TRANSMITTAL OF VARIANCES TO PROJECT SPECIFIC PLANS

This letter serves to transmit variances to the following Project Specific Plans (PSP): PSP for Lead delineation in the Area 2, Phase I (A2P1) Firing Range; PSP for Lead Delineation in the Area 1, Phase II (A1P2) Trap Range; and A2P1 Delineation of Areas Exceeding Waste Acceptance Criteria (WAC). The variances do not involve a significant change in scope.

PROJECT TITLE: A2PI Delineation of Areas Exceeding WAC (Rev. 0)

PROJECT TITLE: PSP for Lead Delineation in the A2PI Firing Range

ATTACHMENT A. AREA 2 PHASE I ABOVE - WAC AREA.
SAMPLE LOCATIONS SWU-5-41 THRU SWU-5-44

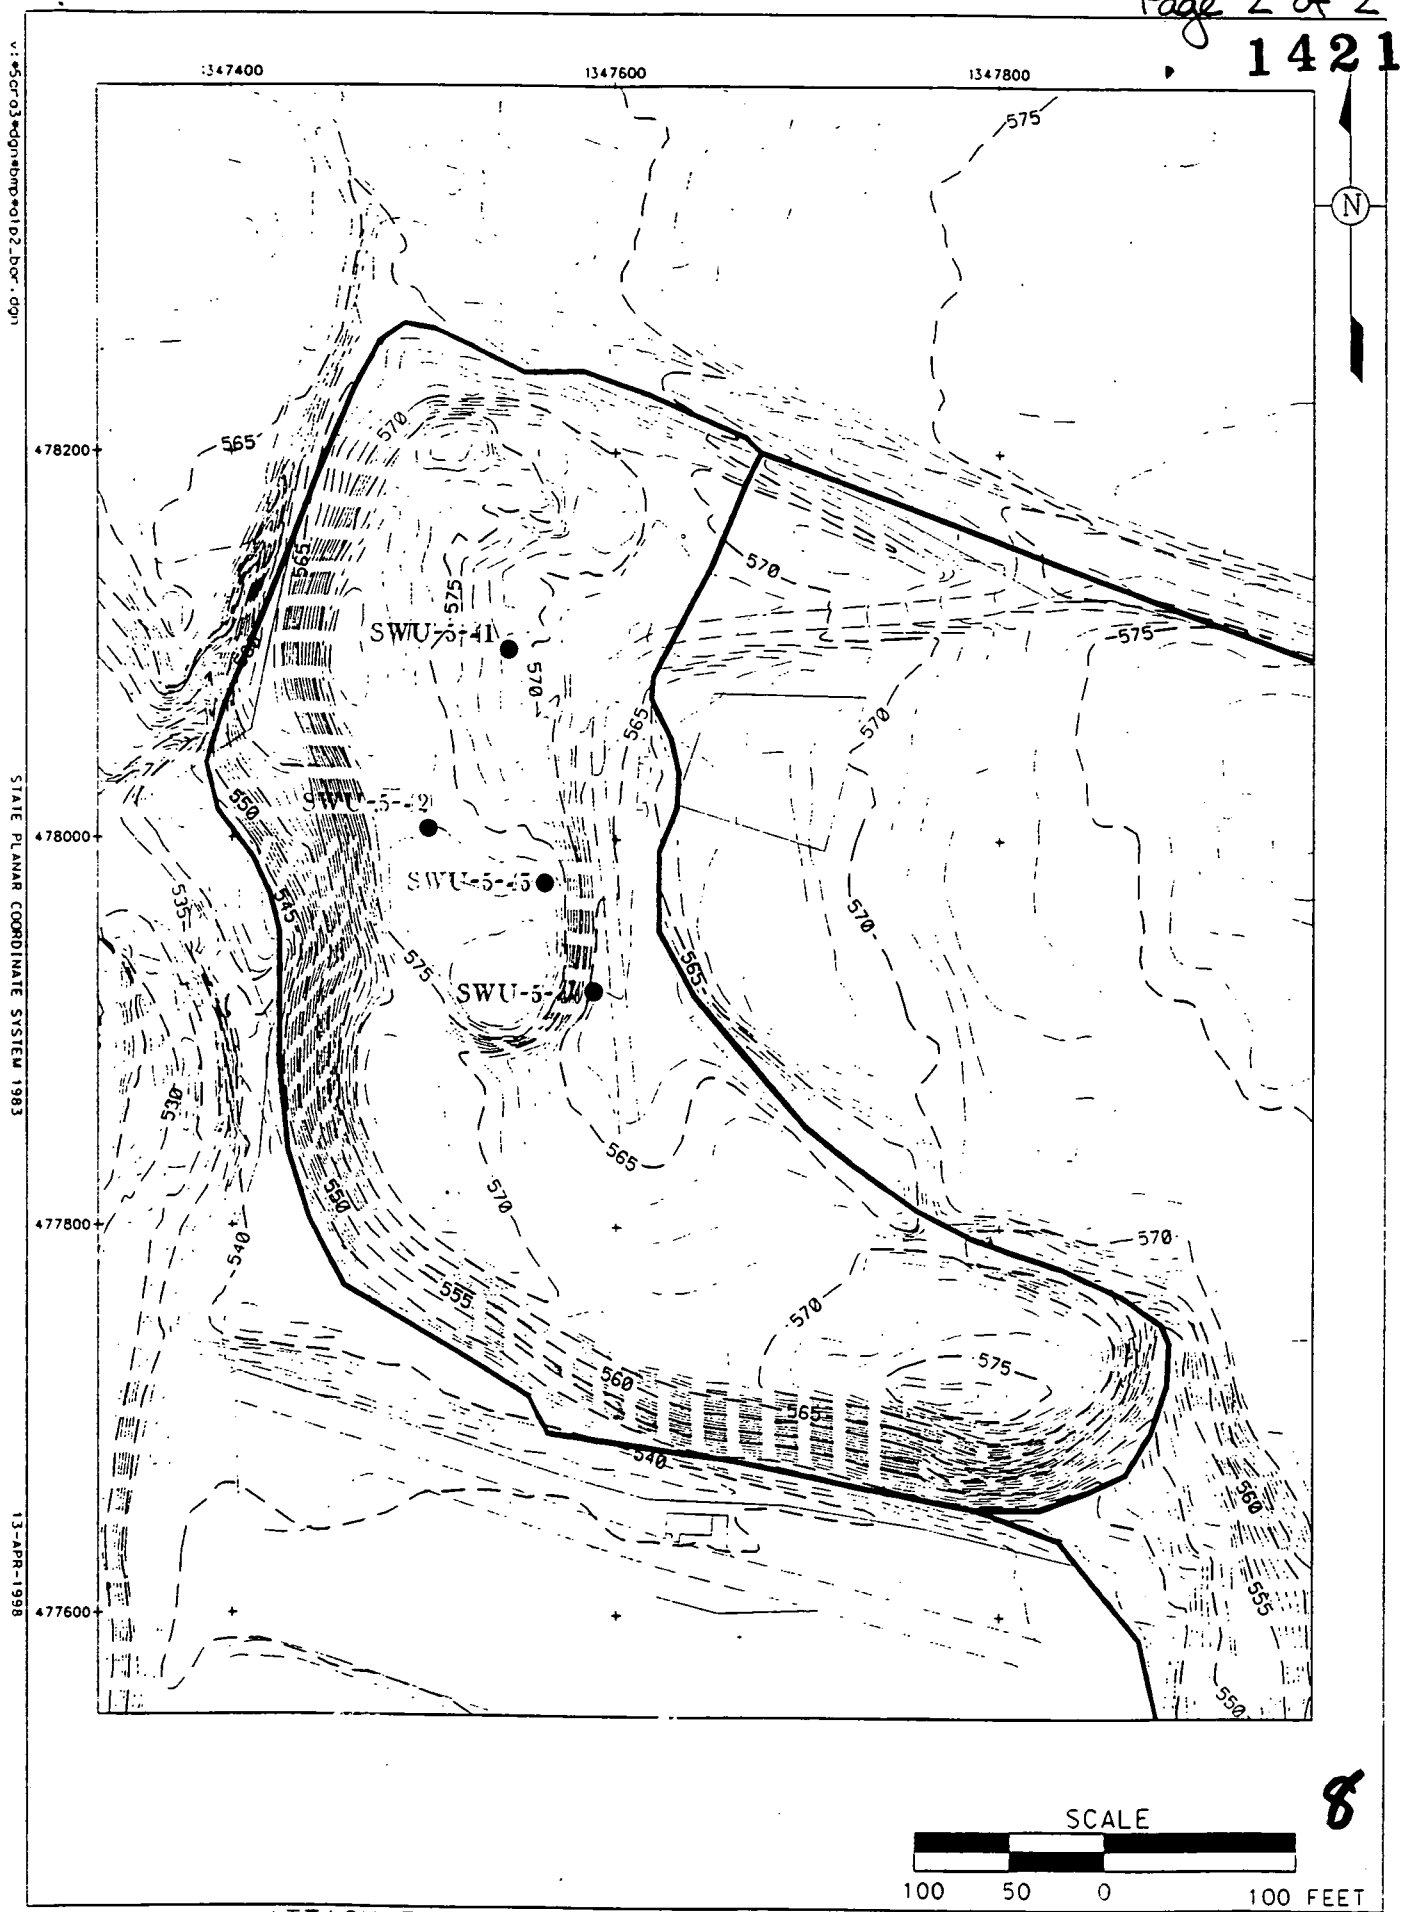
At the request of the Ohio Environmental Protection Agency (OEPA), additional borings will be completed in SWU-5. All soil samples will be beta-gamma scanned and collected in accordance to PSP 20400-PSP-0001, Rev. 0 as discussed in Sections 1.3.2 and 2.5.3 with the following exceptions:

The following sample points are added:

SWU-5-41	Easting: 1347543	Northing: 478097.5	Elevation: 571.76 ft msl
SWU-5-42	Easting: 1347500.8	Northing: 478005.17	Elevation: 576.2 ft msl
SWU-5-43	Easting: 1347562.29	Northing: 477977.12	Elevation: 576.2 ft msl
SWU-5-44	Easting: 1347588.3	Northing: 477920.98	Elevation: 563.4 ft msl

Section 2.5.3 of PSP 20400-PSP-0001, Rev.0 states that analytical results will be used to determine placement of additional boreholes. Per the Characterization Lead, and at the request of the OEPA, additional borings are necessary to bound the southeastern, western and northern edges of above-WAC contamination.

FIGURE D-56. AREA 2, PHASE I FIRING RANGE, ADDITIONAL SAMPLE LOCATIONS

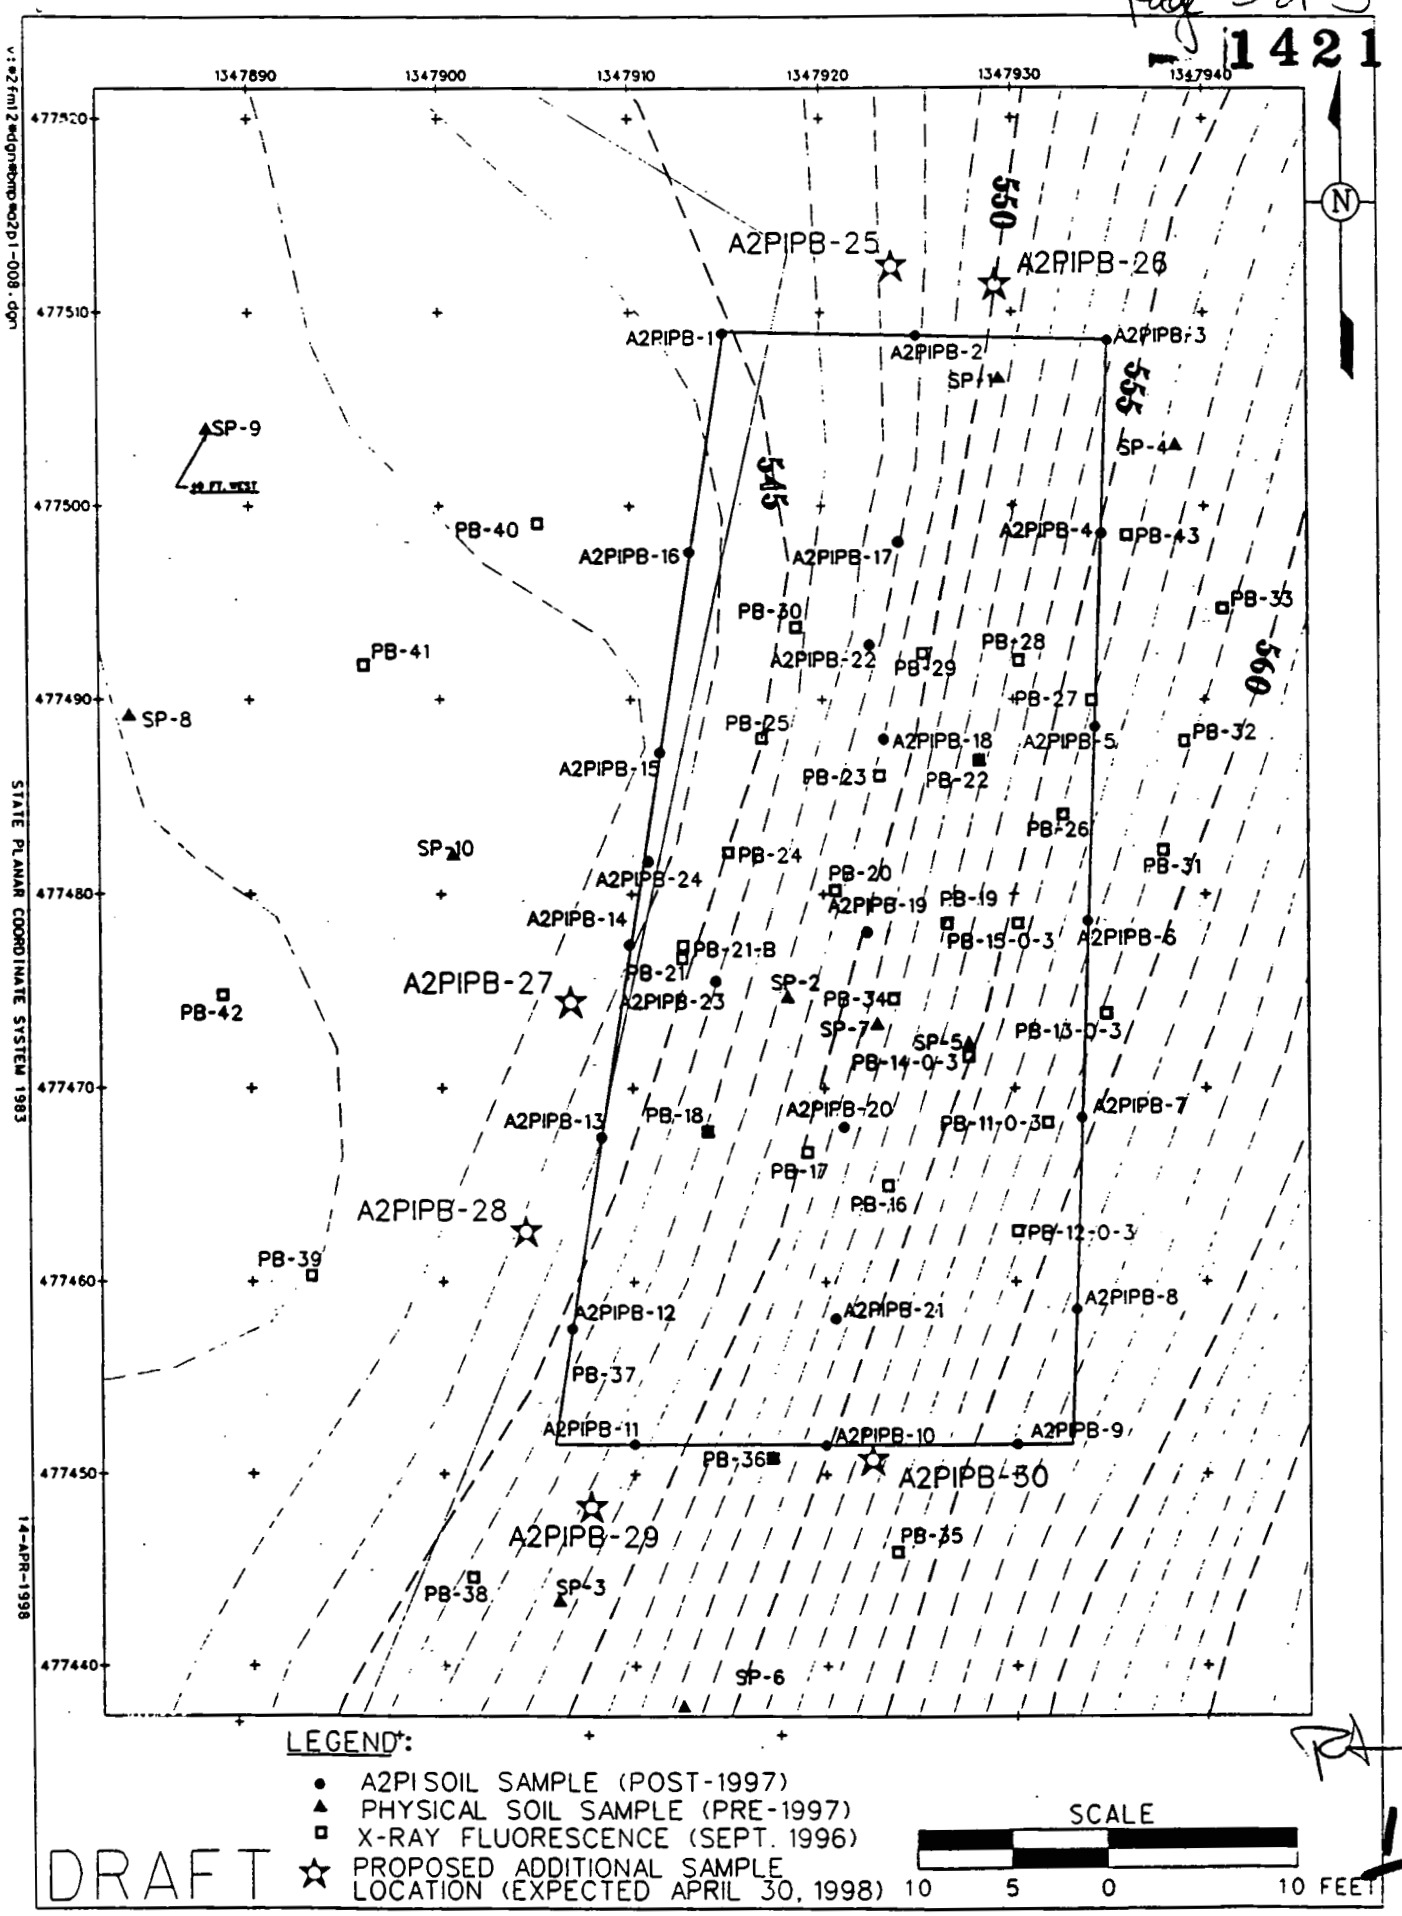
Six additional borings (A2PIPB-25, A2PIPB-26, A2PIPB-27, A2PIPB-28, A2PIPB-29, and A2PIPB-30, see attached) will be completed in the Area 2, Phase I Firing Range area to bound the limits of soil contamination. A2PIPB-25, A2PIPB-26, A2PIPB-29, and A2PIPB-30 will be completed to a depth of 5 feet. For these four locations, samples will be collected at every 6-inch interval to a depth of 3.5 feet and submitted for analysis; from 3.5 to 4.5 feet, only intervals containing bullets or bullet fragments will be collected and submitted for analysis. All four locations will have a sample collected at the 4.5 to 5 foot interval (or at the bottom of the boring if refusal is encountered) and submitted for analysis. For sample locations A2PIPB-27 and A2PIPB-28, the borings will be completed to a total depth of 3 feet; for these two locations, samples will be collected at every 6-inch interval and submitted for analysis.

A2PIPB-25	Easting:	1347923.7	Northing: 477512.4
A2PIPB-26	Easting:	1347929.2	Northing: 477511.4
A2PIPB-27	Easting:	1347906.8	Northing: 477474.4
A2PIPB-28	Easting:	1347904.4	Northing: 477462.6
A2PIPB-29	Easting:	1347907.8	Northing: 477448.3
A2PIPB-30	Easting:	1347922.4	Northing: 477450.8

Per Section 1.2 of the PSP, and at the request of the Ohio Environmental Protection Agency, additional soil samples may be collected.
